**PLANNING & ZONING DEPARTMENT**  
**Before the Planning & Zoning Commission**  
**Meeting of 28 May 2024**

**CONSENT AGENDA ITEM**  
**STAFF REPORT**

Subdivision Final Plat approval for Franklin Village North No. 3 a RS6 (Single-Family Residential) zoning district; a 15.31 acre parcel #R2093901000 at 0 Cherry Ln (located in the SW 1/4 of Section 2, T3N, R2W, BM) for Franklin Village Development (SPF-00256-2024).

DATE: May 16, 2024  
TO: Nampa Planning & Zoning Department  
FROM: Daniel Badger, P.E. –City Engineer  
CC: Tom Points, P.E. – Senior Public Works Director  
SUBJECT: **SPF-00256-2024 – Franklin Village North Subdivision No. 3 – Engineering Review Memo**

FIGURE D103.6 FIRE LANE SIGNS

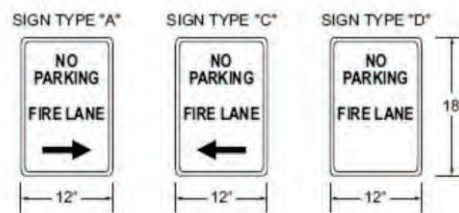
10. Fire apparatus access roads shall not exceed 10 percent in grade. (IFC D103.2)
11. For streets having a width less than 33 feet back of curb to back of curb parking shall be restricted on one side; for streets having a width less than 27 feet back of curb to back of curb parking shall be restricted on both sides. A note on the face of the final plat is required noting the parking restriction prior to signing of the final plat. In addition, No Parking signs shall be installed in accordance with the requirements of the IFC. (IFC 503.8).

FIGURE D103.1 DEAD-END FIRE APPARATUS ACCESS ROAD TURNAROUND

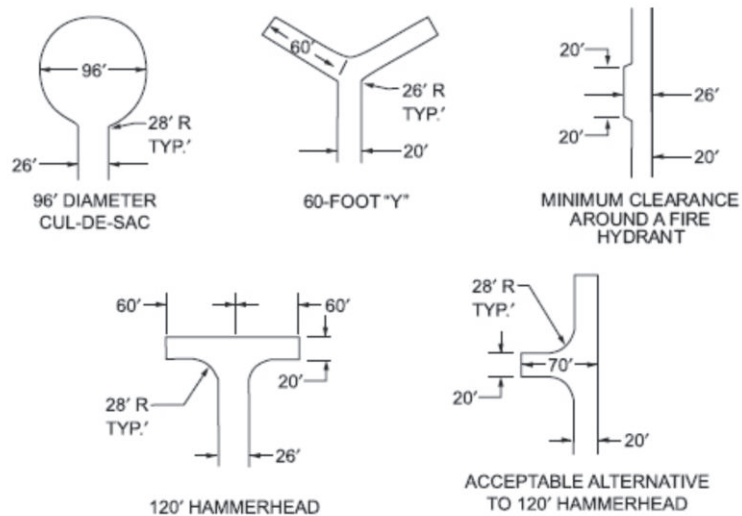
5. Dead-end fire apparatus access roads exceeding 150 feet in length shall be provided with an approved area for turning around fire apparatus. (IFC 503.2.5)
